DRAINAGE INFORMATION SHEET

PROJECT TITLE: VALLEJOS OFFICE BLDG. 2      ZONE ATLAS/DRNG. FILE #: H22/D64  
DRB #:      EPC #:      WORK ORDER #:  
LEGAL DESCRIPTION:  
CITY ADDRESS: 12306 MENAUL BLVD. NE 87112  
ENGINEERING FIRM: HALL ENGINEERING, INC.      CONTACT: RICHARD HALL  
ADDRESS: 6840 2ND ST., NW 87107      PHONE: 345-1064 FAX 344-5404  
OWNER: ANTHONY VALLEJOS      CONTACT:  
ADDRESS: 12306 MENAUL BLVD. NE      PHONE: 298-6363  
ARCHITECT: CHRIS LARSEN      CONTACT:  
ADDRESS: 202 CENTRAL AVE., SE      PHONE: 247-3705  
SURVEYOR: HALL ENGINEERING      CONTACT:  
ADDRESS:      PHONE:  
CONTRACTOR:      CONTACT:  
ADDRESS:      PHONE:

**RE: VALLEJOS OFFICE BLDG. #2 (H22/D64), 12306 MENUAL BLVD. NE.  
ENGINEER'S CERTIFICATION FOR CERTIFICATE OF OCCUPANCY.  
ENGINEER'S CERTIFICATION DATED APRIL 10, 1997.**

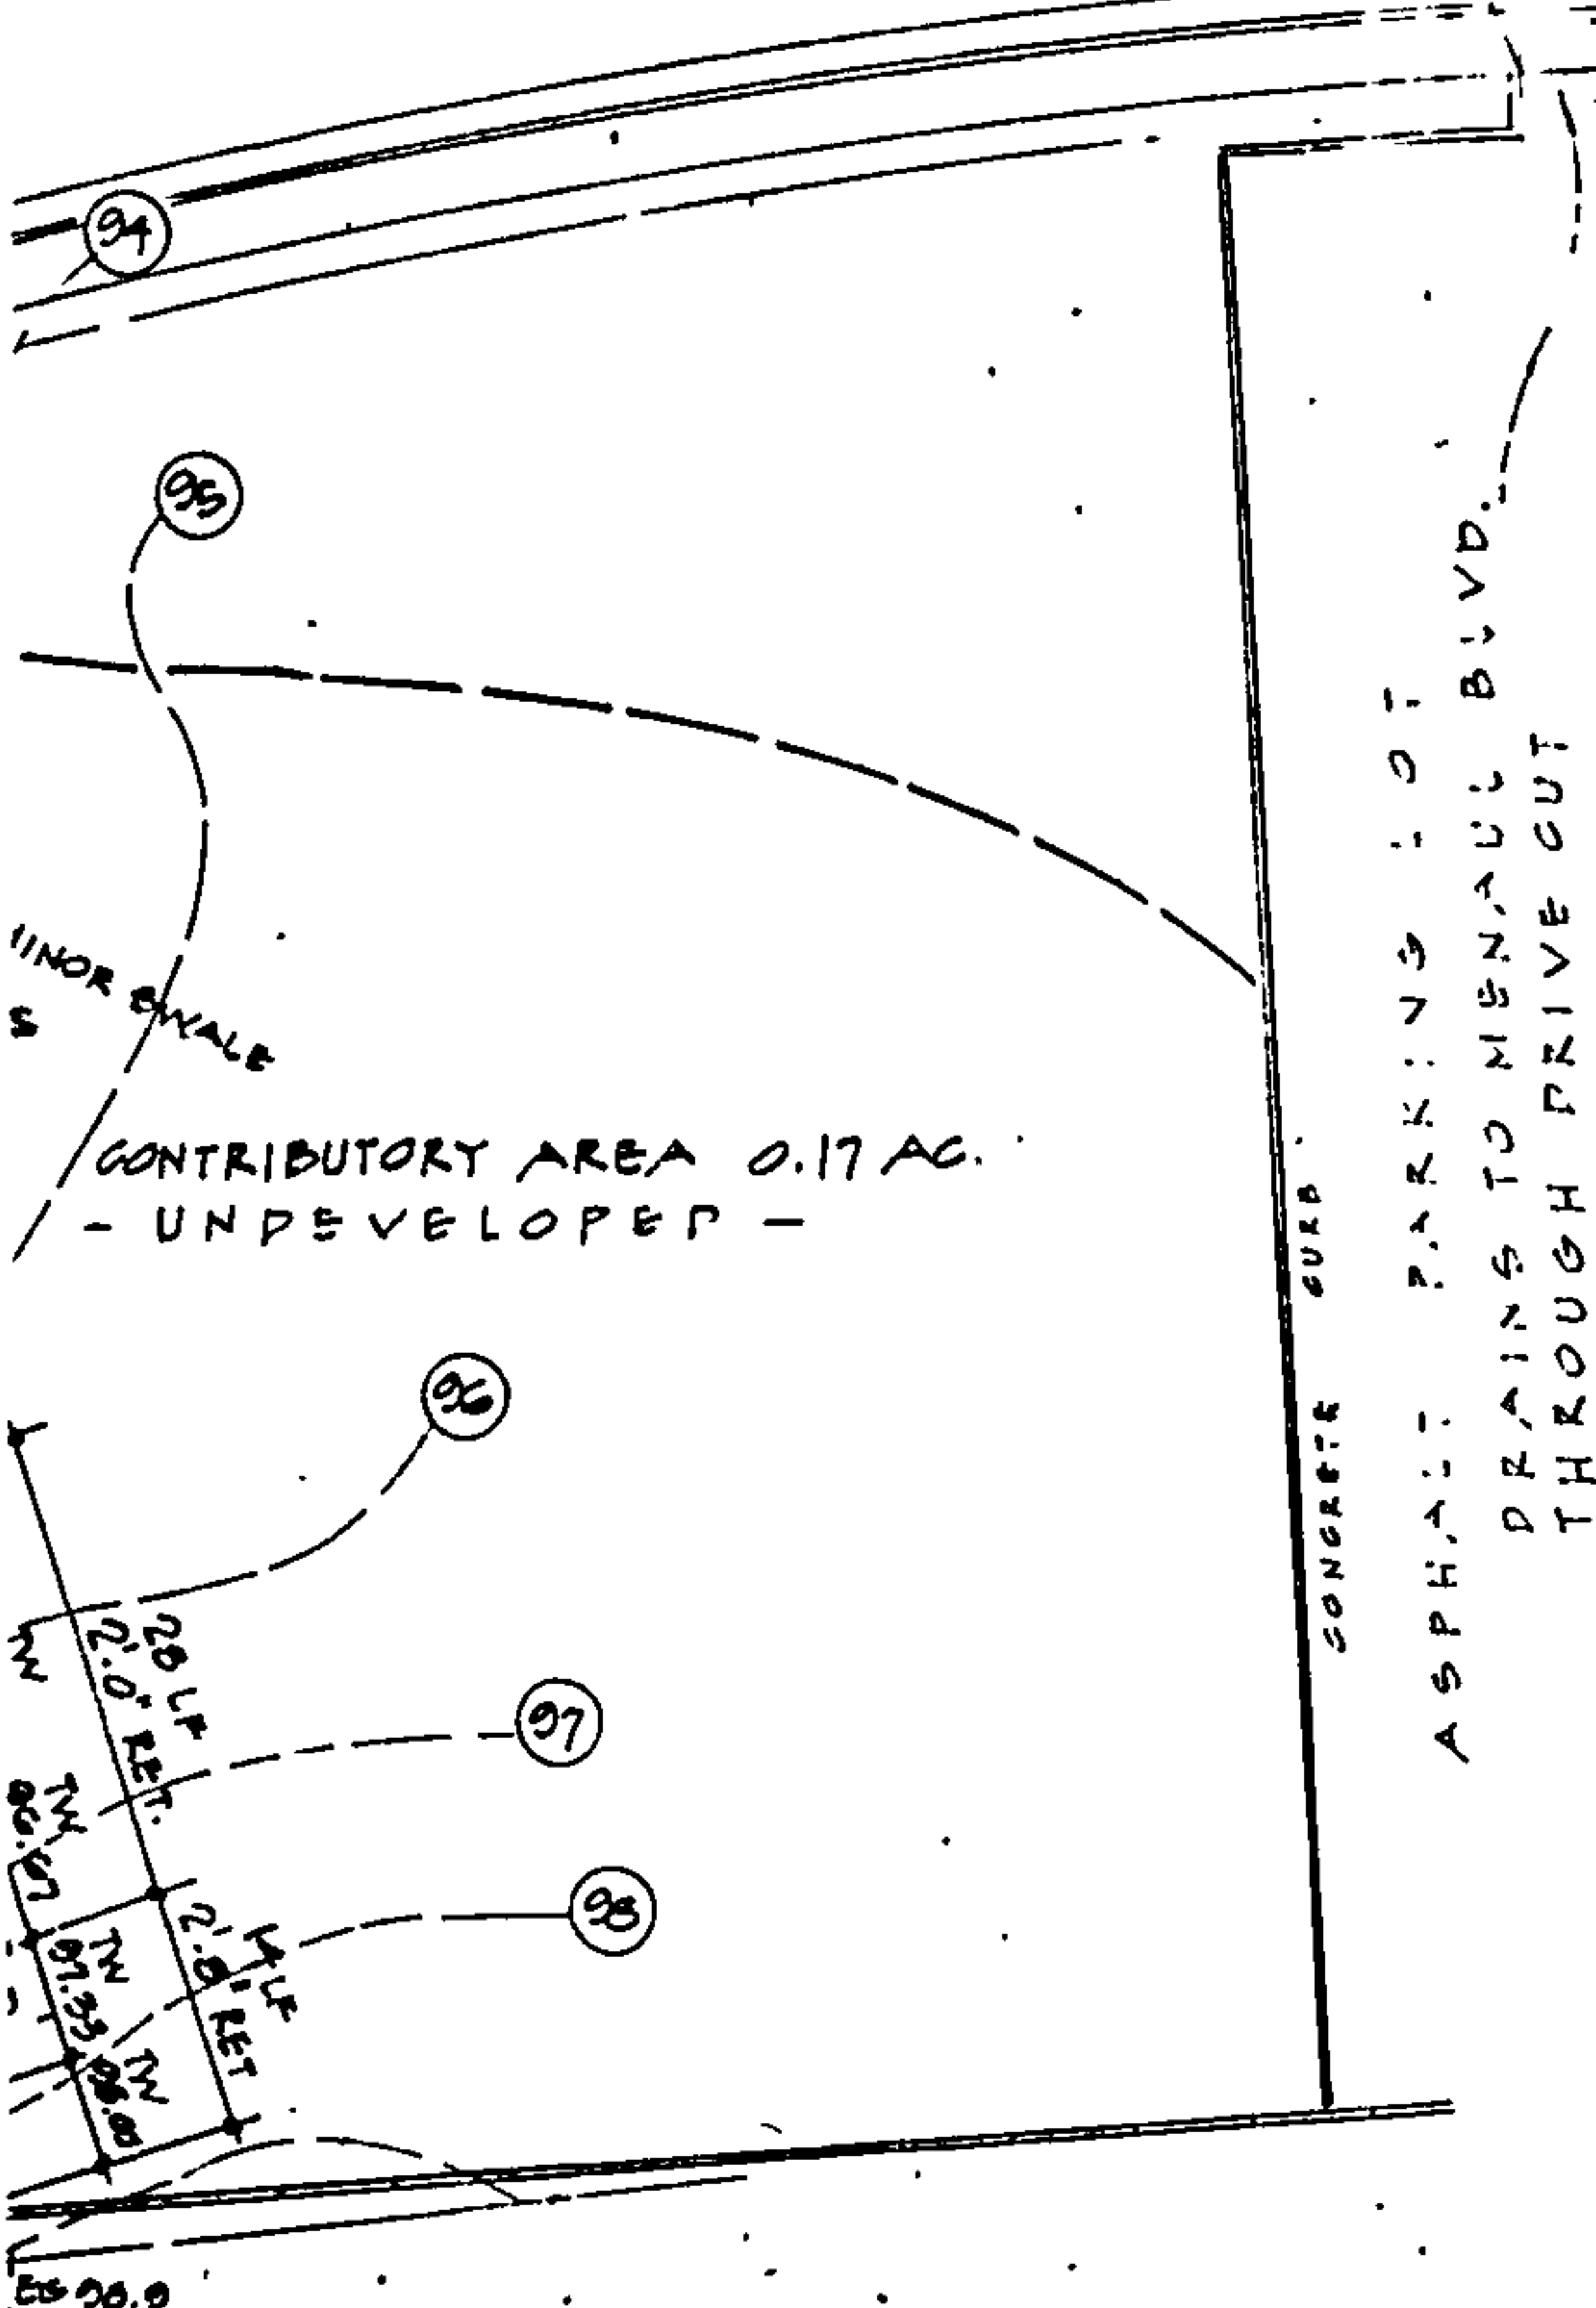
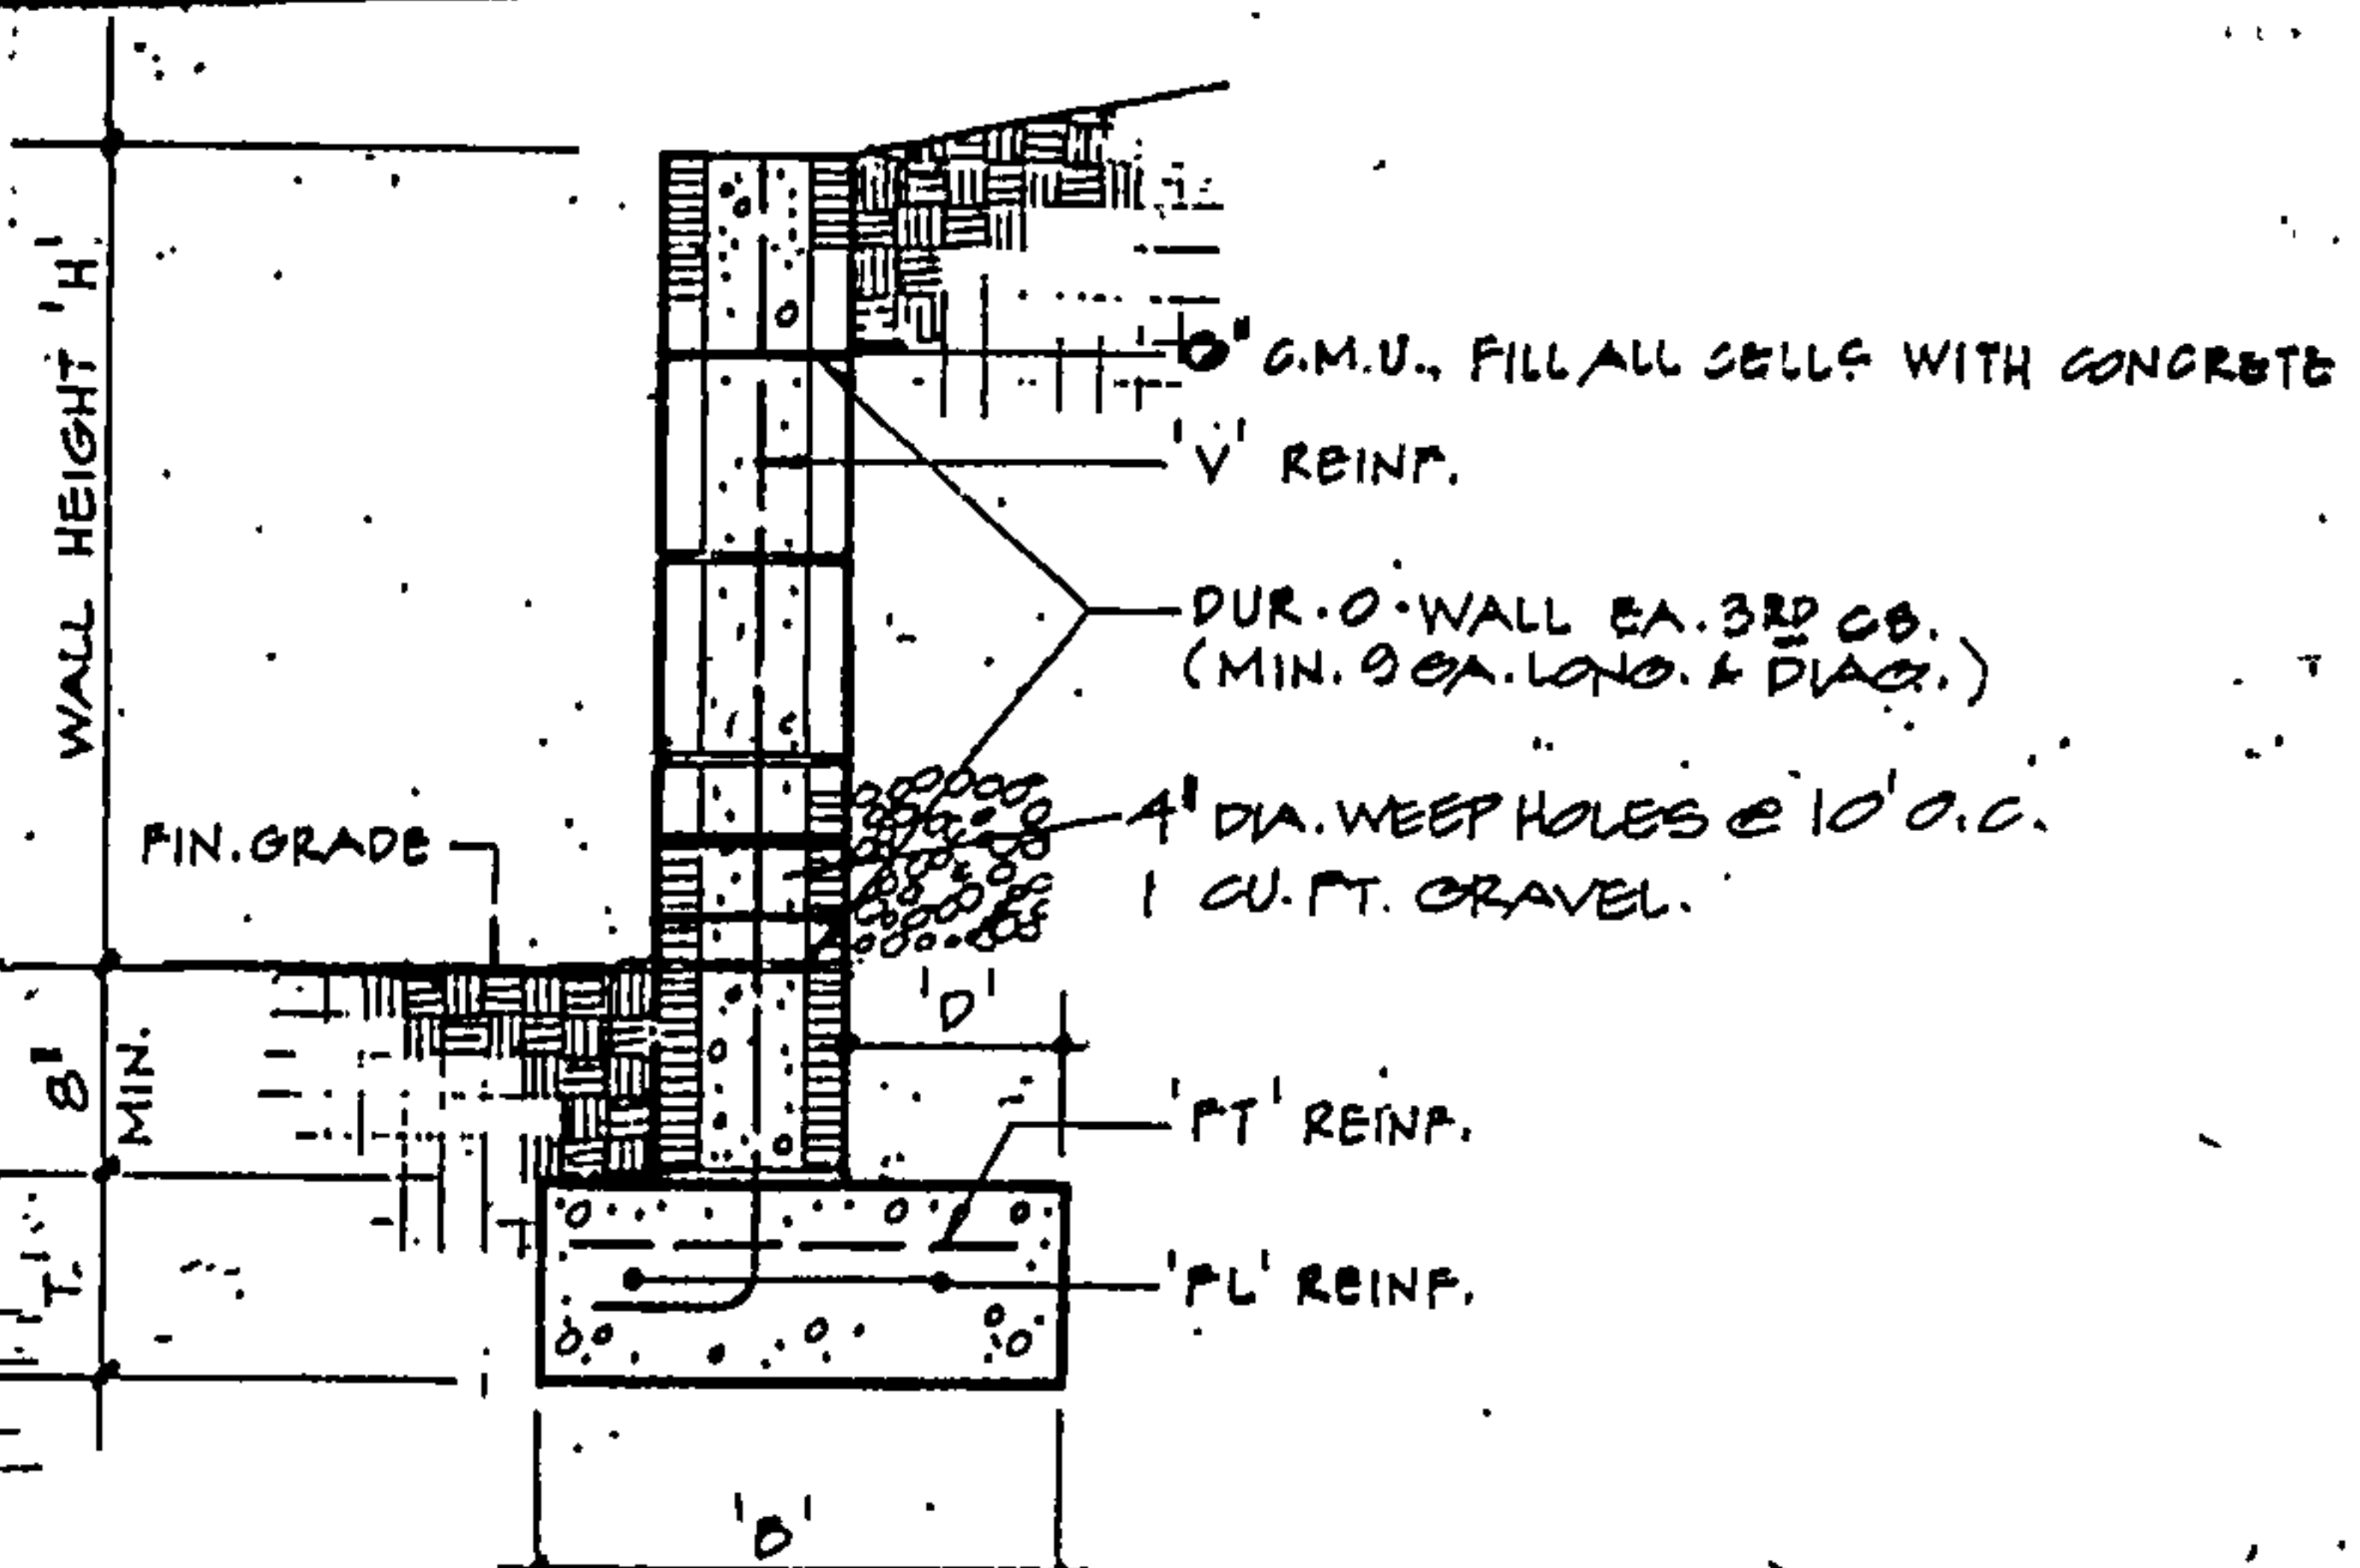
1. Is this site in a 100 year Flood Plain?
2. Provide hydrograph for detention pond per Figure A-3, DPM Section 22.2. (mark up attached). City Hydrology believes that required storage volume calculated is too low.
3. An S.O.19 is required for the sidewalk culvert. Add the Approval Block and Notice to Contractor to the Drainage Plan (form attached).
4. A Private Facility Drainage Covenant must be executed & filed for the Detention Pond (form attached).

We have complied with the items mentioned in your letter and have incorporated a second building with an extended parking area on the plan. There is to be no undeveloped area on the site, as amended.

1. This site is not in a 100-year flood zone but is contributory to one about 1/2 mile to the west near Juan Tabo Boulevard.
2. A hydrograph for detention has been calculated for the amended site and included on the plan sheet. The required storage volume was calculated to be 1220 ft<sup>3</sup>. 1237 ft<sup>3</sup> may be accommodated in the basin as designed.
3. S.O.19 signature block and notes to contractor have been added to the sheet.
4. Text has been amended where noted.
5. Private Facility Drainage Covenant form was forwarded to the Owner for his acknowledgement.
